From: Meg Lamm <meglamm@gmail.com>
Sent: Saturday, March 6, 2021 10:04 AM
To: Park Commission <pacommission@cityofmadison.com>
Cc: Meg Lamm <meglamm@gmail.com>
Subject: Vilas Park Master Plan

From: Emily Kohlase <emilykohlase@gmail.com>
Sent: Saturday, March 6, 2021 11:01 AM
To: Park Commission <pacommission@cityofmadison.com>
Subject: Vilas Park Master Plan (Agenda Item 64455)

I am writing in regard to the Vilas Park Master Plan, which will be Agenda Item 64455 on the March 10 BPC meeting.

Current conditions with green space between basketball and tennis courts:

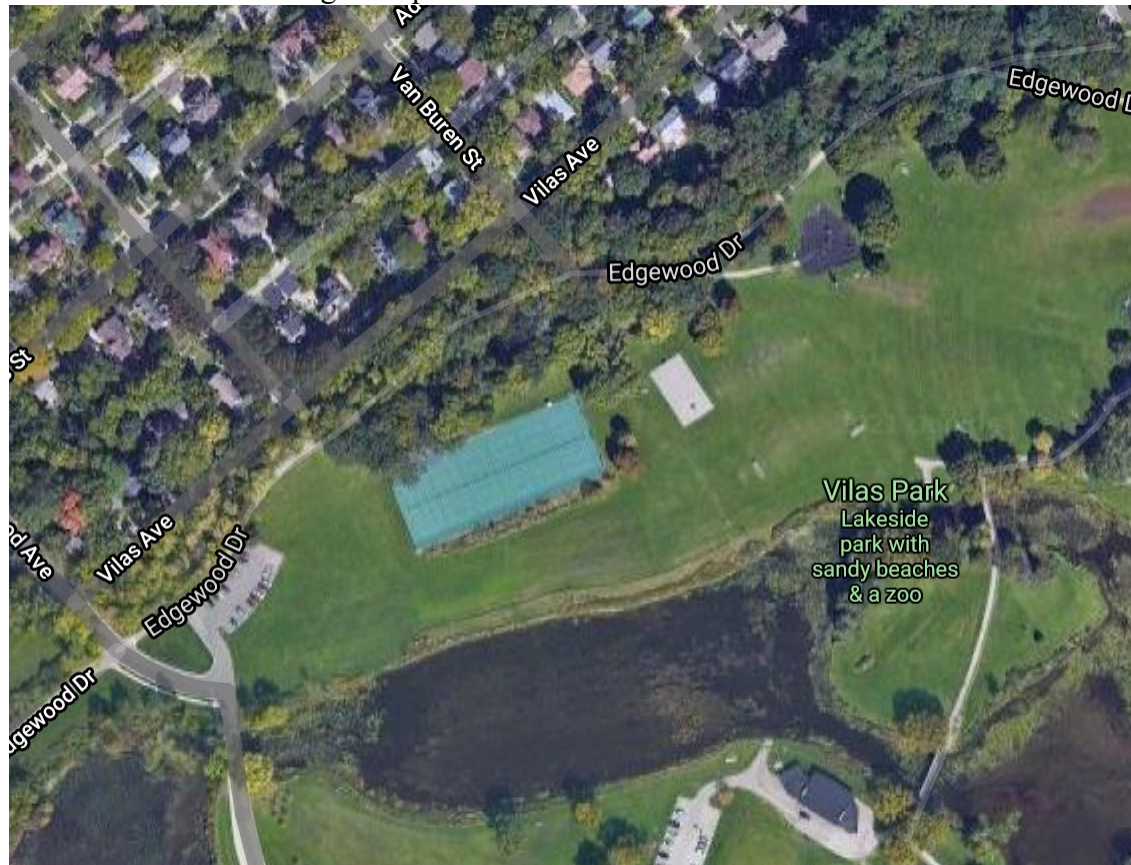
5. In the park currently, there is plenty of grass around the basketball court (see image below). I would urge you to retain the current separation of the basketball courts from the tennis/pickleball courts, and retain this green space, rather than having all of the athletic courts attached together, making a big monolith that would make the area feel very built up.
